**STATE OF HAWAII  
OFFICE OF HAWAIIAN AFFAIRS  
560 NORTH NIMITZ HIGHWAY, SUITE 200  
HONOLULU, HAWAII 96817**

**REQUEST FOR QUOTE LPM 2019-23  
INSTALLATION OF GRAVELED ENTRY AND GRAVELED AREA AT WAHIAWĀ  
PROPERTY**

**ADDENDUM No. 01**

**Updated Exhibit 4: Project Site Entry and Area to be Graveled**

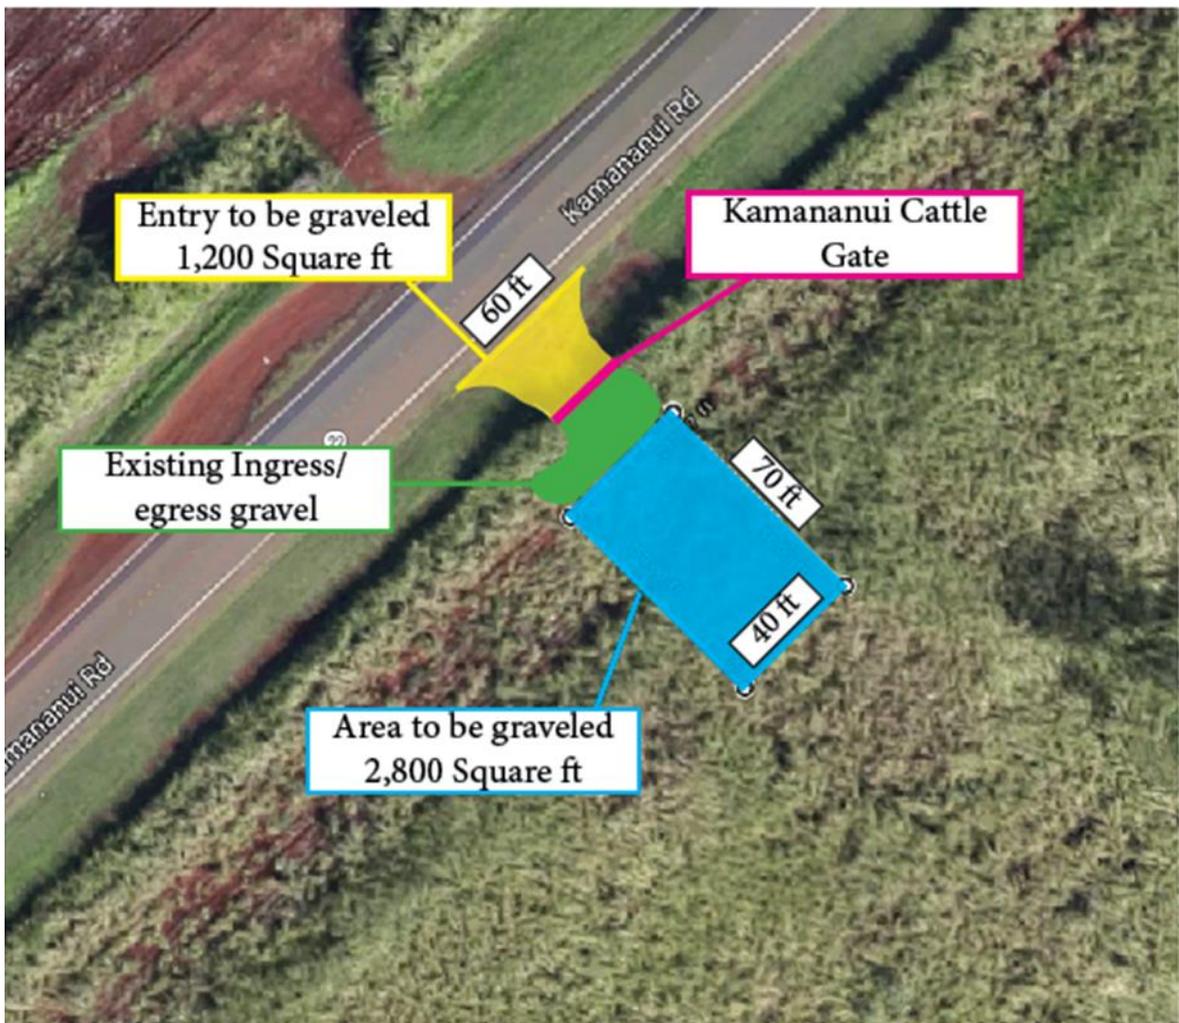
- 2) Item 1 and 2 on page 2 under the Scope of Work of the RFQ LPM 2019-23 reads:

1. The Successful Vendor shall provide a price quote for a proposed course of action to lay a geotextile road clothe and install a graveled entry with 6" minus surge rock or a similar material, as shown on Exhibit 4. See Exhibit 4: Project Site Entry and Area to be Graveled.
2. The Successful Vendor shall also provide a price quote to lay a geotextile road clothe and gravel using crusher ready asphalt, comingled unprocessed asphalt, or a similar material for a 0.5-acre area and a 1-acre area. The vendor shall provide an itemized cost break down of all parts of this project.

**Item 1 and 2 on page 2 under the Scope of Work of the RFQ LPM 2019-23 is hereby amended to read as follows:**

1. The Successful Vendor shall provide a price quote for a proposed course of action to lay a geotextile road cloth, Mirafi RS380i, and install a graveled entry of 1,200 square feet with an 8 inch layer of 6 inch minus surge rock. See Updated Exhibit 4: Project Site Entry and Area to be Graveled.
2. The Successful Vendor shall also provide a price quote to lay a geotextile road cloth, Mirafi RS380i, grade 8 inch deep and grub area, with compaction of the area of 95 percent of the standard proctor, and gravel using an 8 inch layer of #1 angular gravel or #3 stones for a 2,800 square feet lot. The vendor shall provide an itemized cost break down of all parts of this project.
